Subject: Docket Number 070-03098  
Duke Cogema Stone & Webster  
Mixed Oxide Fuel Fabrication Facility  
Responses to the Request for Additional Information  
on the Environmental Report

**RESPONSES TO  
REQUEST FOR ADDITIONAL INFORMATION  
FOR THE DUKE COGEMA STONE & WEBSTER (DCS)  
MIXED OXIDE (MOX) FUEL FABRICATION FACILITY (FFF)  
ENVIRONMENTAL REPORT (ER)**

Figure 37-1 Site Infrastructure Development Concept

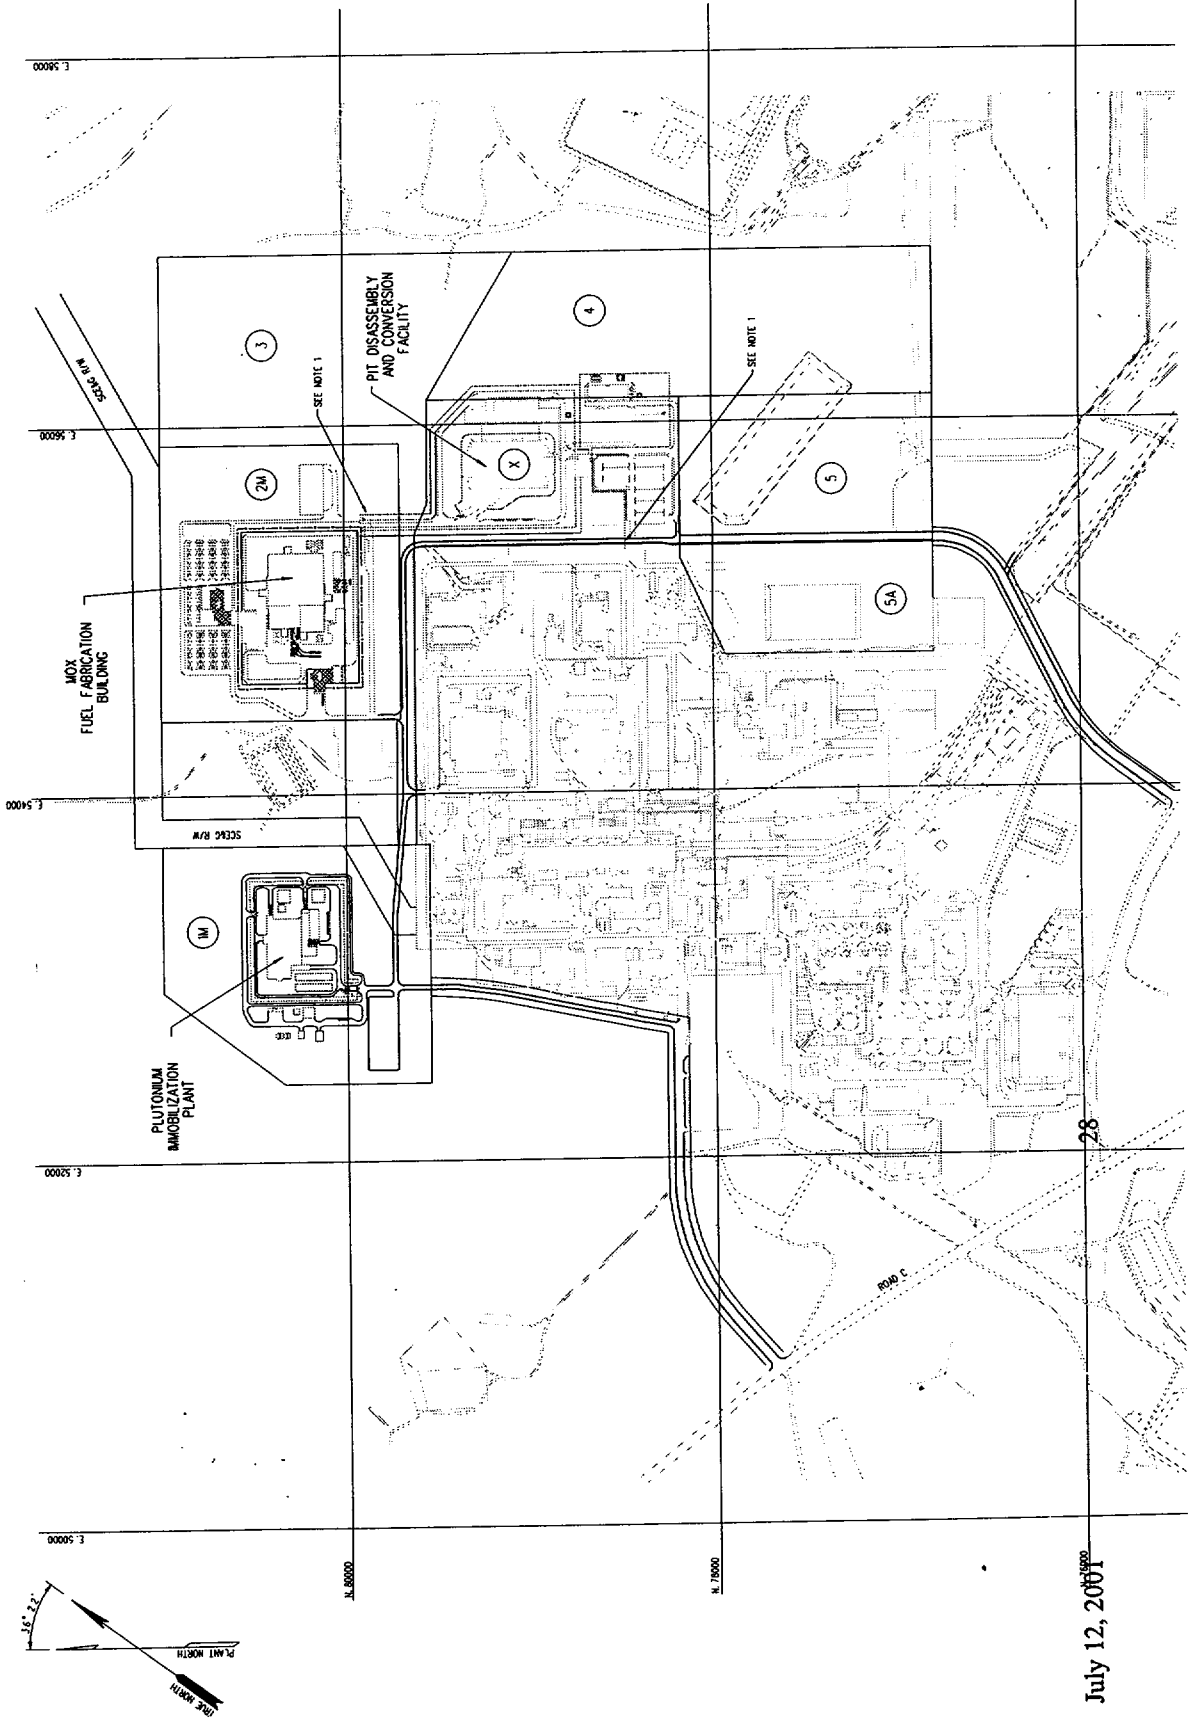
27. Section 5.1.11, Infrastructure. The statement is made in reference to infrastructure that "... upgrades include clearing and grading of all three sites, developing integrated stormwater flow patterns for all three sites, providing utility services to all three sites, and providing any new access roads". Details of these upgrades, particularly design and location information, are needed to support the impact assessment of areas disturbed during construction. How much land will be disturbed for new access roads needed for MOX FFF construction? Provide a map showing the approximate locations of new access roads. Also, provide the types of habitats these upgrades would be routed through.

Designs for the MOX MFFF and PDCF facilities are at varying design detail and design for the PIP facility has not been initiated. Therefore, infrastructure to support these facilities is at a preconceptual stage and subject to change. The following information represents current design and is subject to change in the final design.

Because only 1,300 to 1,500 feet of the proposed roadway (in two pieces) is not in previously cleared road rights-of-ways, the total land area expected to be disturbed in connection with road work is less than 5 acres. See attached Figure 27-1, Site Infrastructure Development Concept.

Road upgrades for ingress and egress to the MFFF site will be conducted in existing traffic rights-of-ways. Relocation of the South Carolina Electric & Gas power line, digital cable lines, telephone lines, and adjacent survey area includes flat sandy uplands, flanking slopes that transition to erosion ditches and a small stream bottom. Within these topographic areas, the following plant communities are noted; upland longleaf pine, successional mixed pine-hardwood, dry oak-pine slopes, mesic hardwood slope, moist-bottom mixed pine-hardwood forest and a series of early successional systems. Assessment of the general ecological conditions and potential wetland areas for the proposed plutonium disposition facilities found no wetland areas within proposed construction site, no endangered or threatened species and no rare or unique ecological resources.

Utilities for the PIP, MFFF and PDCF will generally be routed along the existing F-Area Limited Area perimeter roadway – to the east and to the north of the road. This corridor also contains existing steam lines. The design of the utilities routing is still at the conceptual phase and will be developed in more detail with each facilities' design effort.

The existing 115KV transmission line entering F-Area from the north crosses the MFFF site and will be rerouted around the facility. The new route for the 115KV line will parallel the MFFF northern boundary and turn south at the eastern boundary of the PIP site. It will rejoin and follow the existing route across the F-Area perimeter road at a point south and west of the closed F-Area seepage basin. The power line relocation is expected to impact approximately 11 acres on the north and west sides of the MFFF site. The ecology of the impacted area is similar to the communities identified for the MFFF site.
